PCN-20220309 TE0715-04 to TE0715-05 Hardware Revision Change

Company	Trenz Electronic GmbH
PCN Number	PCN-20220309
Title	TE0715-04 to TE0715-05 Hardware Revision Change
Subject	Hardware Revision Change
Issue Date	2022-03-14

This change affects all Trenz Electronic TE0715 SoMs of revision 04.

#26 Change schematic documentation.

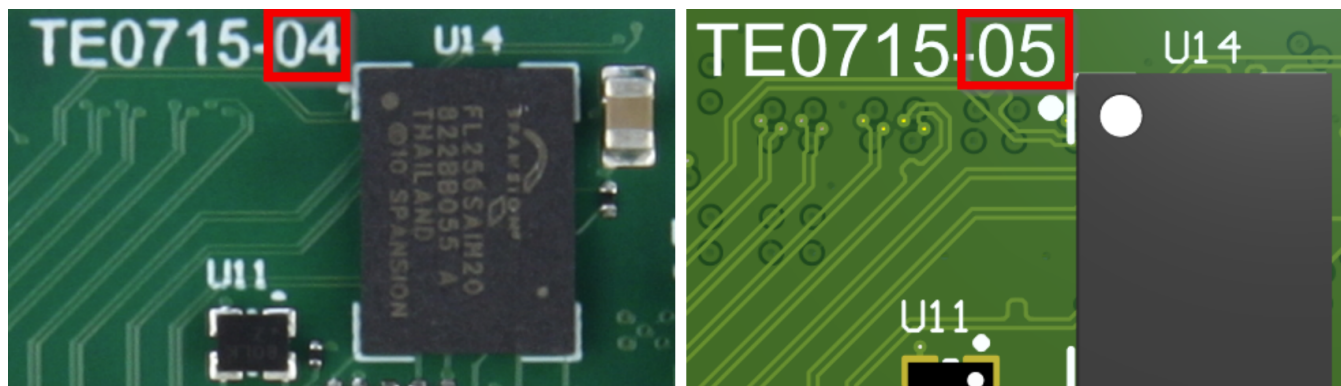
Impact: None. B2B information, legal notices, revision history, system overview, and power diagram are inserted or changed. Schematic page number changes.
